ZBA 2022-29

Petition of Bank of America, NA  
342 Washington Street

#### ZBA 2022-29 BANK OF AMERICA, 342 WASHINGTON STREET

Subject: Bank of America Wellesley  
**Construction Change Narrative Letter**  
Project Number: 005.3722.000  
File Code: 5CD

## APPENDIX B

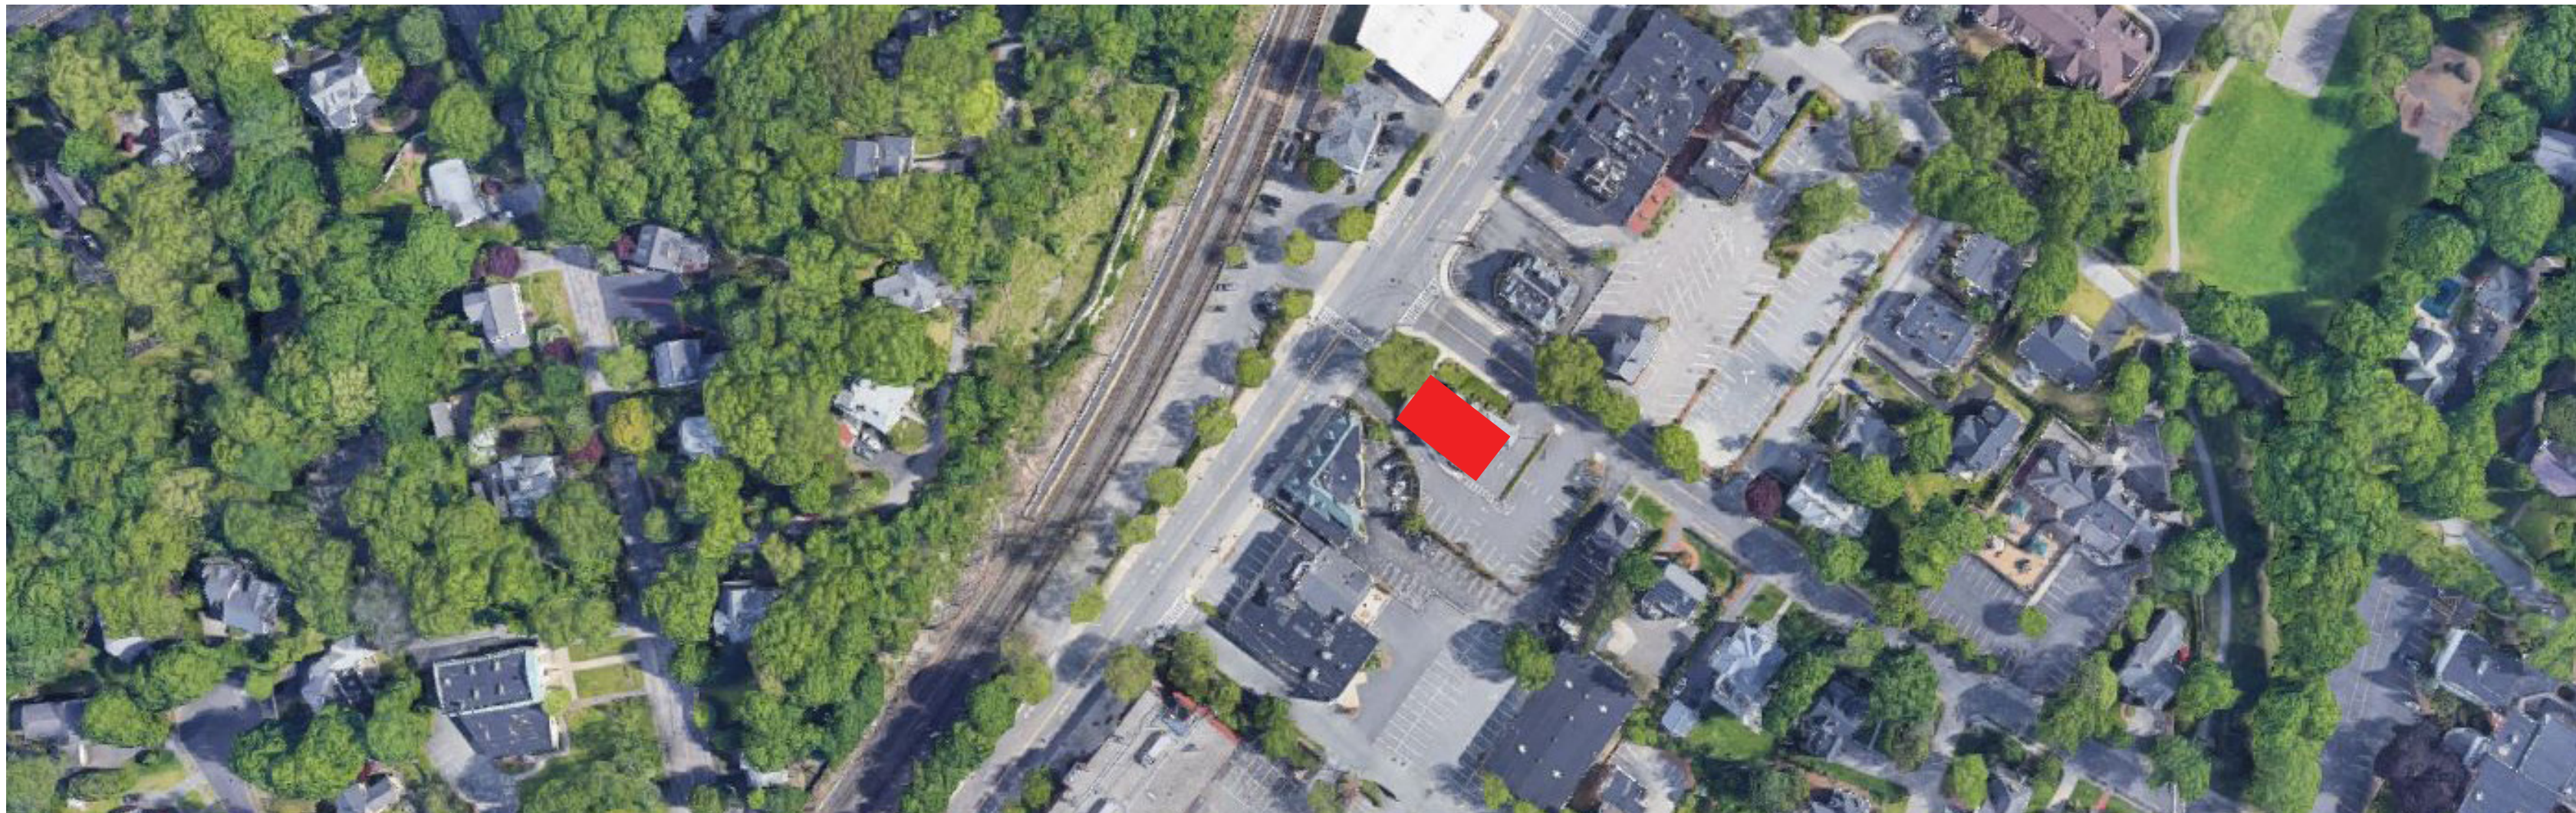
3. **Chimney repair** – Due to the challenges encountered during construction, it is not possible to completely remove the stone of the existing chimney walls. As shown in the images on Appendix 'B', there is a 4" stone wall ledge that protrudes from the existing wall surface. Additionally, the inside face of the chimney wall remains unfinished and can't serve as an exterior wall finish. To achieve a refined appearance for the chimney area, Gensler proposes extending the new brick veneer over the chimney area to provide new wall finishes. For a visual representation, please refer to the rendering on pages AR-03D and AR-03E, as well as the elevation on pages AR-05. Furthermore, detailed information can be found on page AR-11 in the presentation deck.

NEWLY PROPOSED WITH TPO ON CANOPY

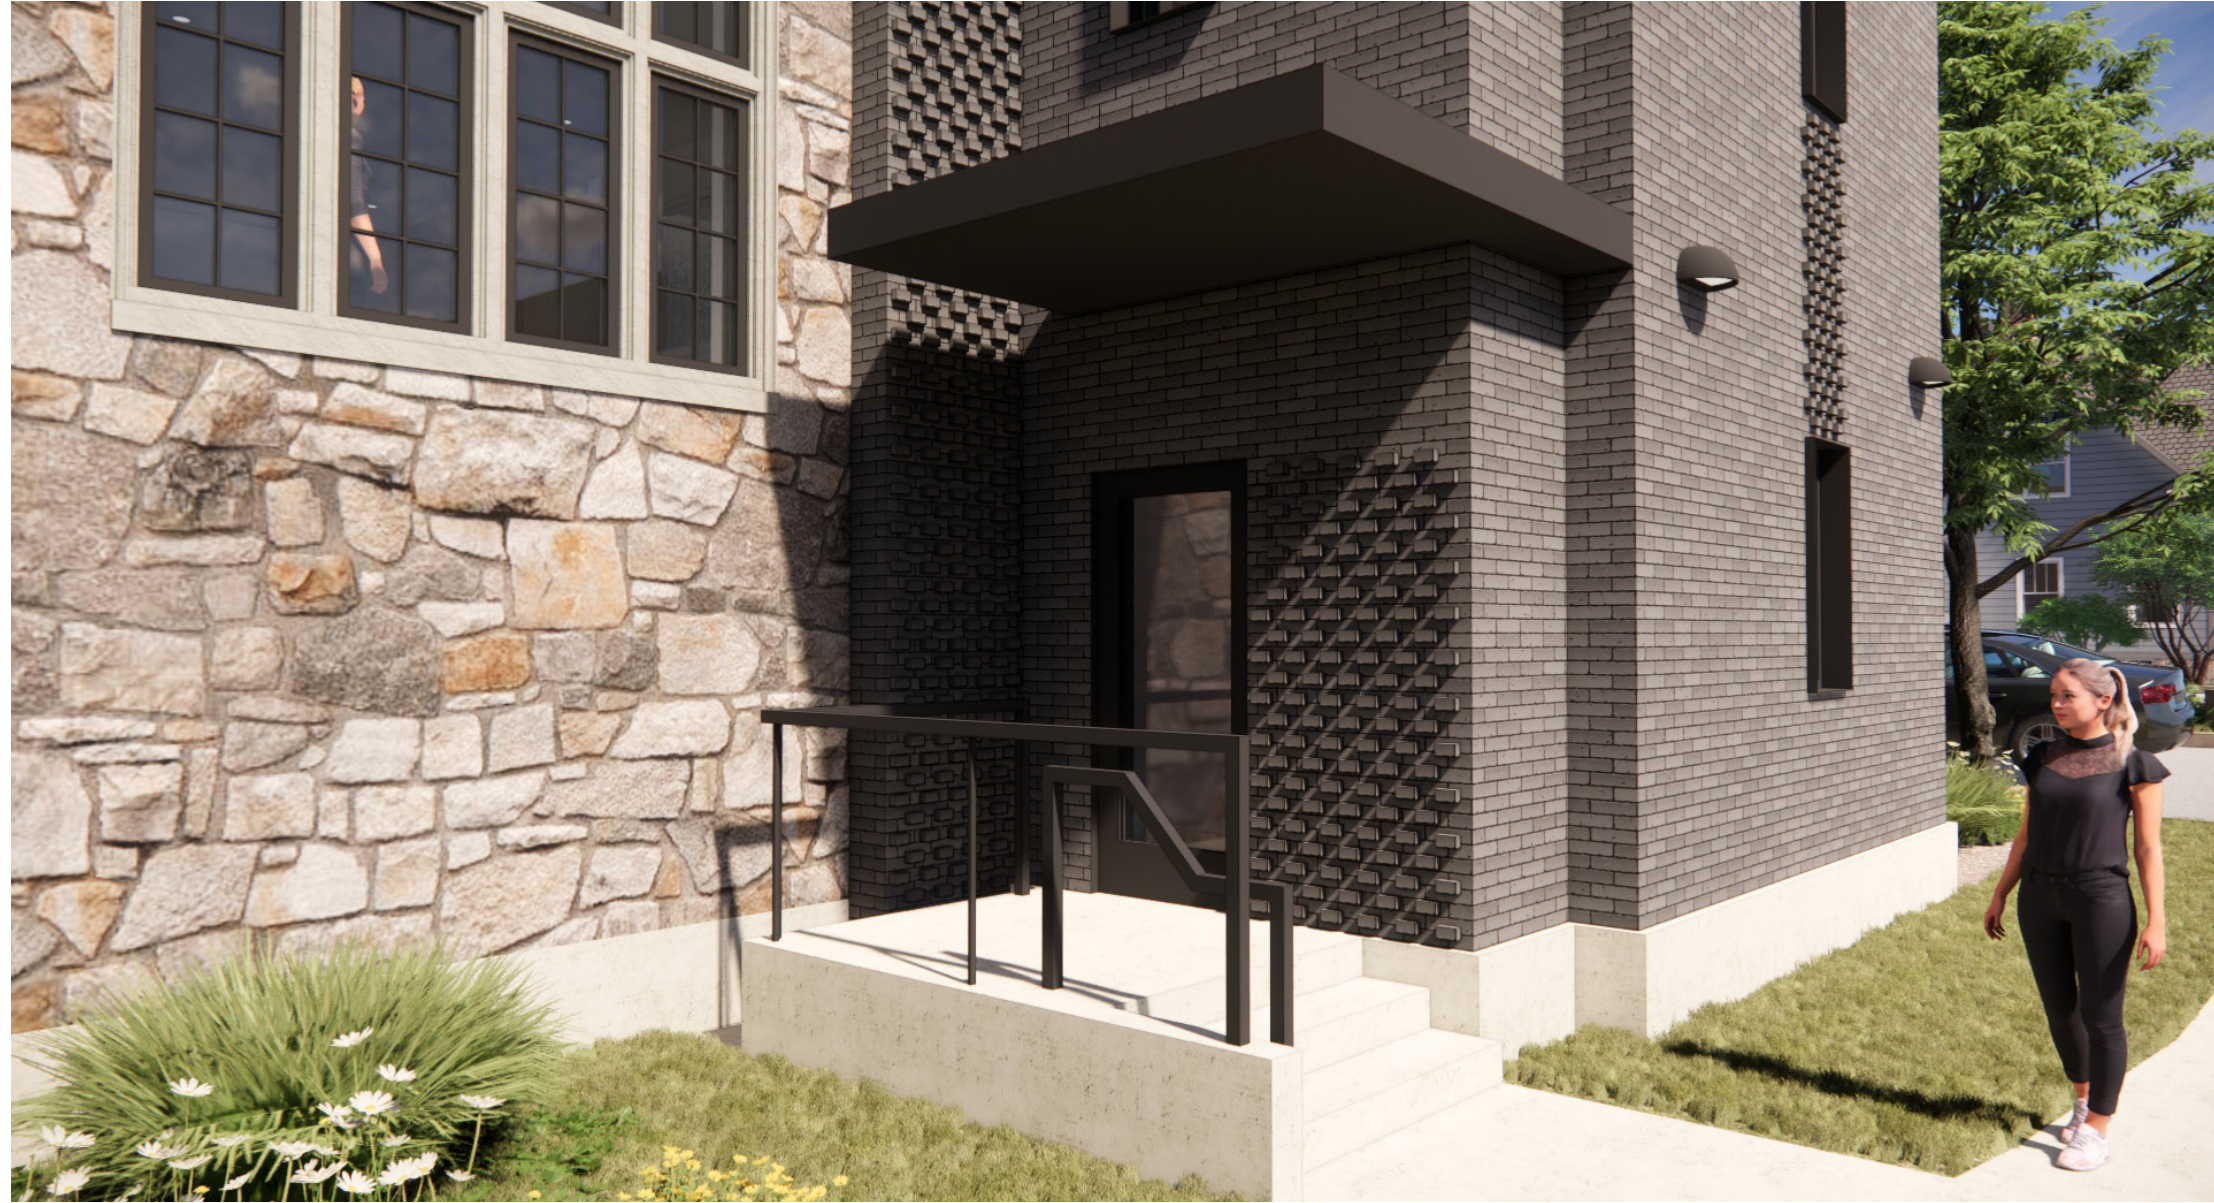
2. **Change top of canopy from metal panel to TPO roofing membrane** – Considering our budget constraints, we propose replacing the metal panel on top of the canopies with TPO roofing membrane. Although the TPO membrane is of a lighter color, due to the angle and height of the canopies, pedestrians will not have a clear visual of the lighter TPO membrane. To get a better understanding, please refer to the rendering provided on page AR-03B and AR-03E in the presentation deck.
